App. No.:	03-2015-PP	Block:	14.27 acres
Meeting:	February 4, 2015	Utilities:	Central water & sewer
Applicant:	Cobblestone Park, LLC	School Dist.:	Medina City
Engineer:	TGC Engineering	Units:	59 in Phases 9 & 10
Zoning:	Cobblestone Park PND	Reviewer:	Susan Hirsch
Site Area:	18.48 acres

Staff Recommendation: Staff recommends **APPROVAL WITH MODIFICATIONS** of the Preliminary Plan for Arbor Lakes at Cobblestone Park Subdivision. Applicant must submit three copies of a corrected Preliminary Plan indicating the following:

PRELIMINARY PLAN

ARBOR LAKES AT COBBLESTONE PHASE 10

SITE PLAN

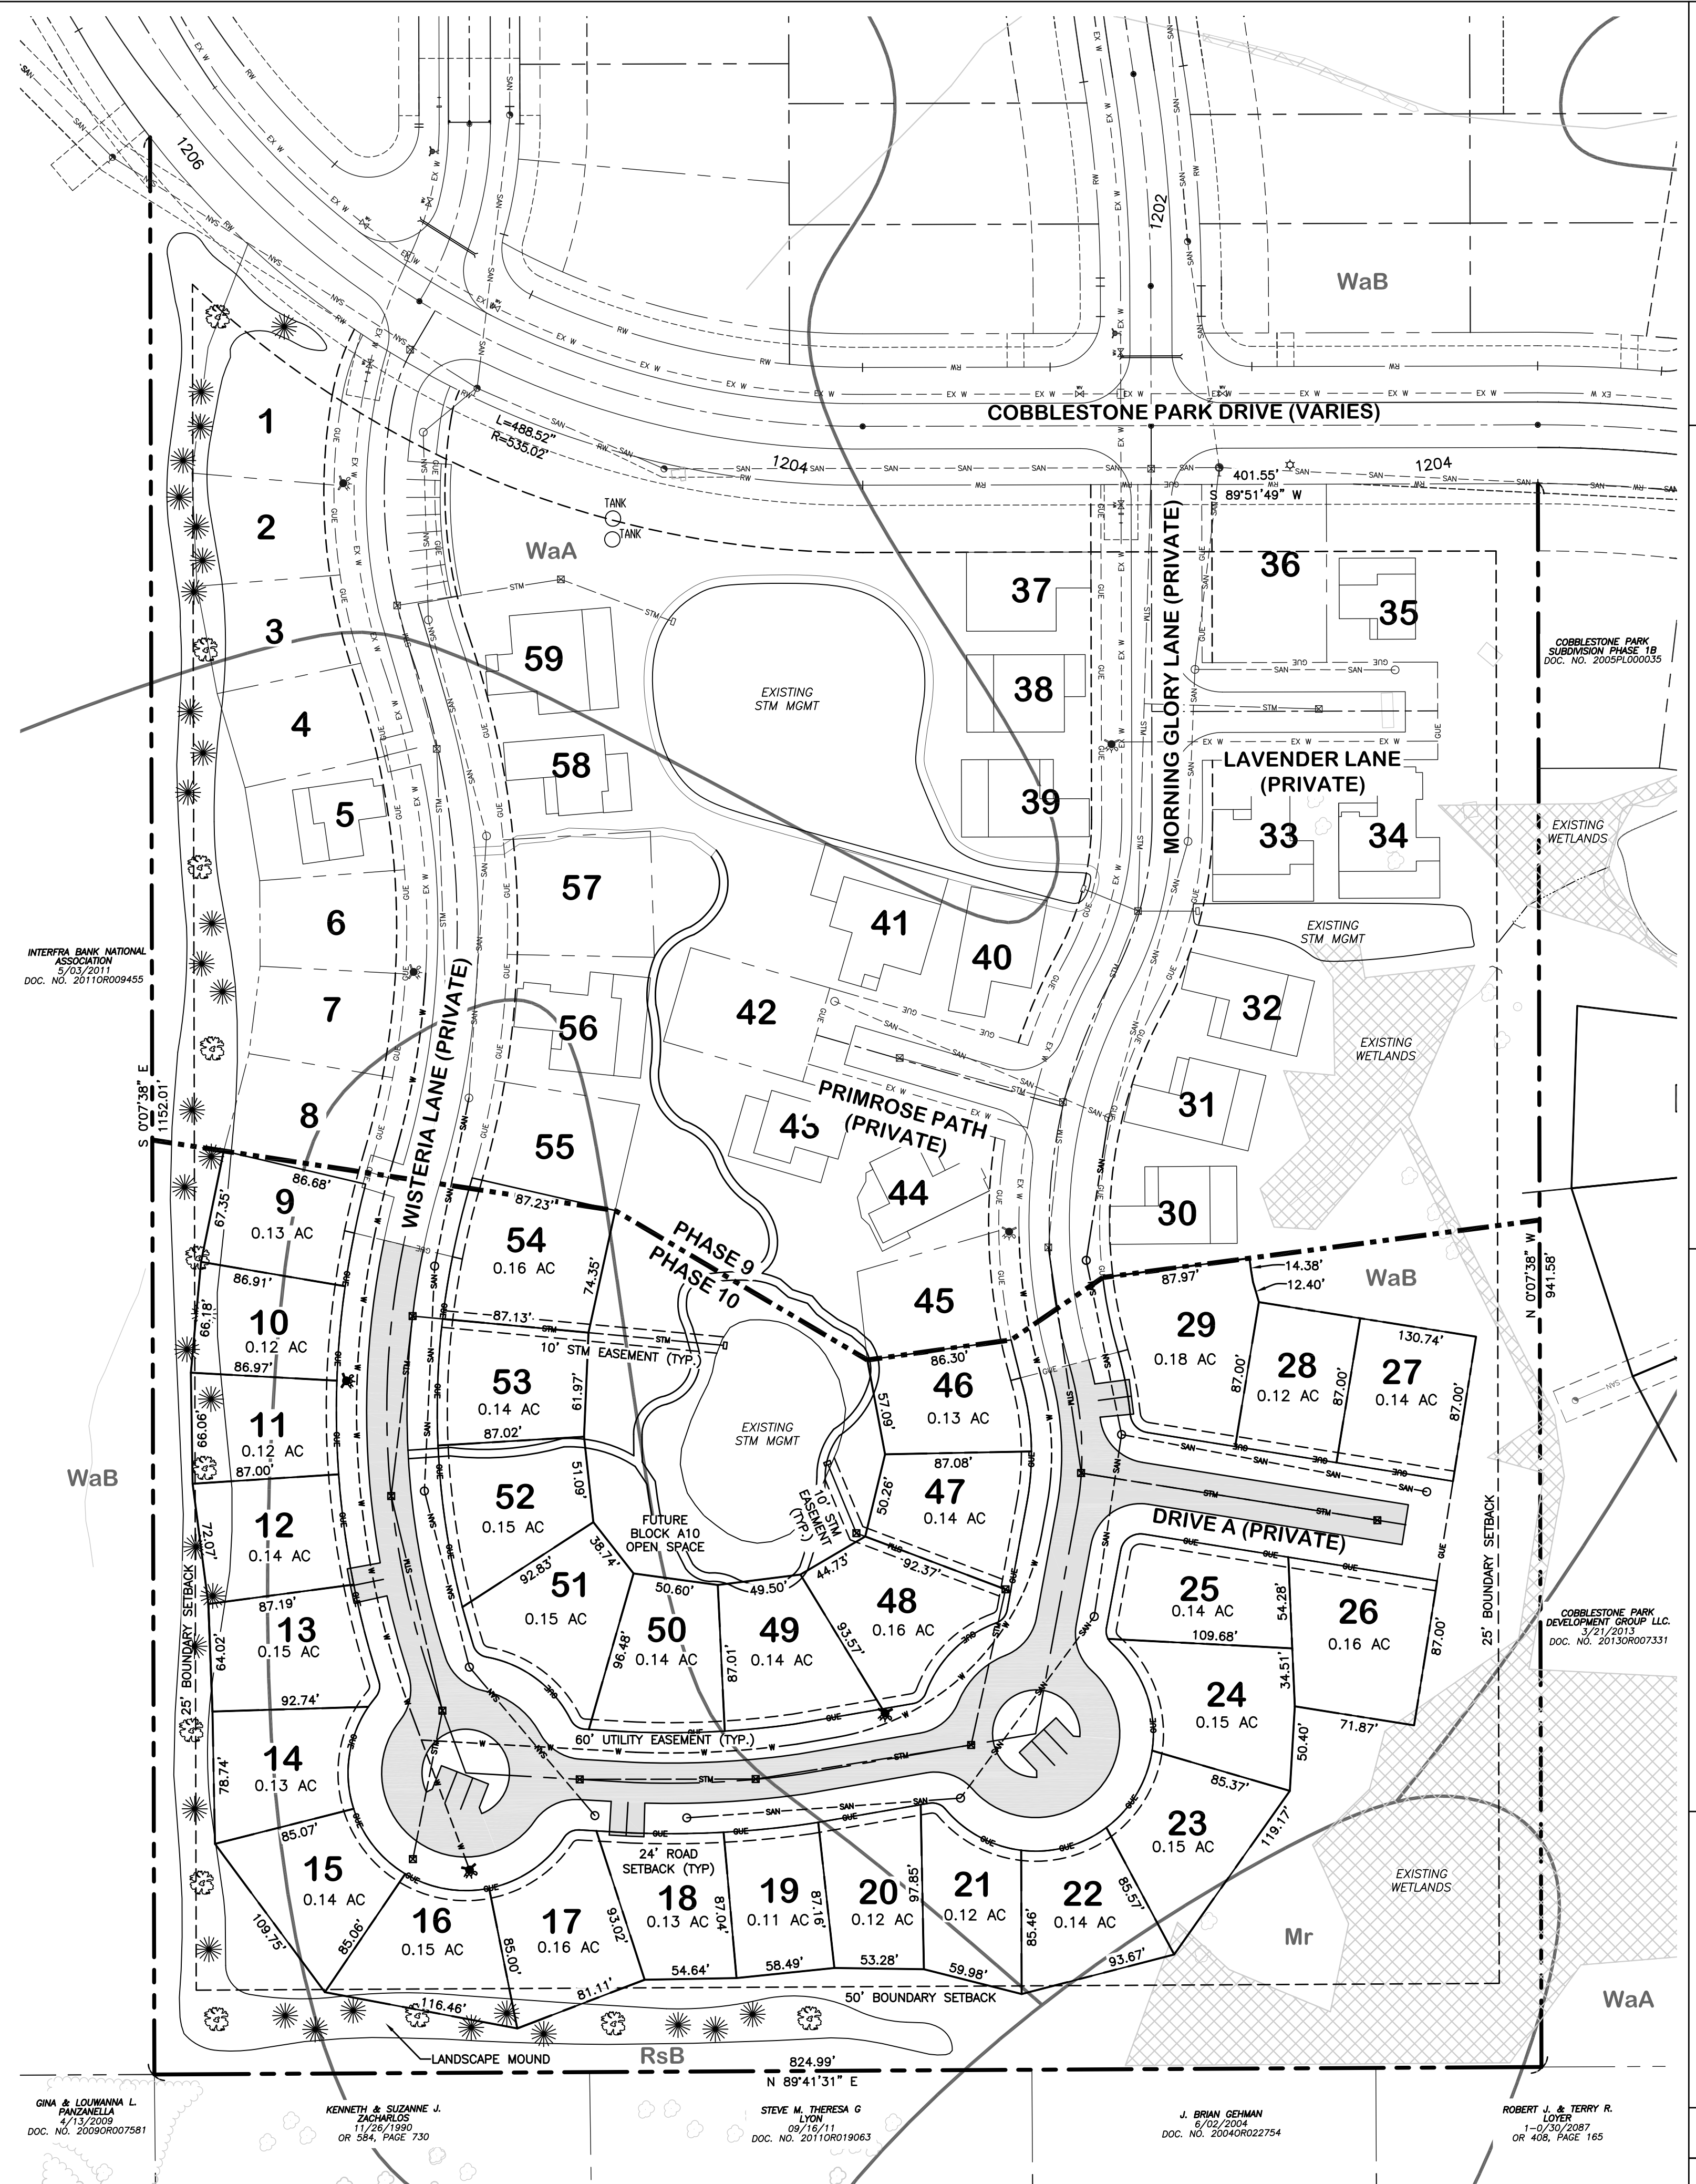
1. *Original approved plan indicates the 38 guest parking spaces would be included while the new plan shows only 25. The number of spaces does meet our current code and there is not a clear reference as to what (if any) the required guest space was at the time of development. Original plan also indicated guest spaces in the northeast portion of the development at the end of Lavender Lane and in between unit 31 & 32. Disbursement of the guest spaces may aid in resolving comment number 2 listed below.*

2. *Envelopes 22, 23 & 26 have wetlands that encroach and the wetland setbacks have been indicated on plan.*
3. *Envelopes appear to be much larger than needed for construction of home; typically envelopes cover enough to place the home and possible deck/patio designed in box type format. These have grown to become sublots. One concern is the maintenance of the area surrounding the homes in the envelopes as the area being maintained around the foot-printed homes. **As discussed with the developer, these should be envelopes and having open space area.***

4. *Phase 9 & 10 should reflect the phase line as indicated in red.*

1. *Show existing contours.*
2. *Proposed landscape mound interrupts the existing drainage. Remove mound and/or install rear yard storm sewer system.*
3. *Are the depicted wetlands based on a new delineation or the original subdivision delineation that expired?*
4. *Stormwater management calculations for site will be required.*
5. *Will easements be taken for the walking path?*

1. The Preliminary Plan title should not include a reference to a phase.
2. The phase line between phases 9 and 10 is incorrect. It must reflect the ROW line established with the Final Plat for Phase 8.

5. Section 570.3 C.3. of the Montville Township Zoning Resolution establishes a 25 foot setback from all Ohio EPA Category 3 Wetlands. Sublots 22, 23 and 26 appear to be impacted by the wetlands and/or the required wetlands setbacks. Deeds for these sublots should include a reference to the existence of the wetlands/wetlands setbacks and the fact that area is not to be disturbed.

6. Wetland setbacks must be indicated on the Preliminary Plan
7. Existing sublots were indicated as a “footprint” of the dwelling on the currently approved

1. Satisfy the Tax Map and Highway Engineer comments listed above.
2. Correct title to exclude a reference to a phase.
3. Correct phase line between Phases 9 and 10 to reflect the line established with the Final Plat for Phase 8.
4. Indicate wetlands setbacks on the Preliminary Plan.
5. Amend HOA documents concerning maintenance of landscaping within the sublots. Any revisions to the original HOA documents must be submitted for transmittal to the Township and Prosecutor’s Office for review and approval prior to the Director signing the Replat.
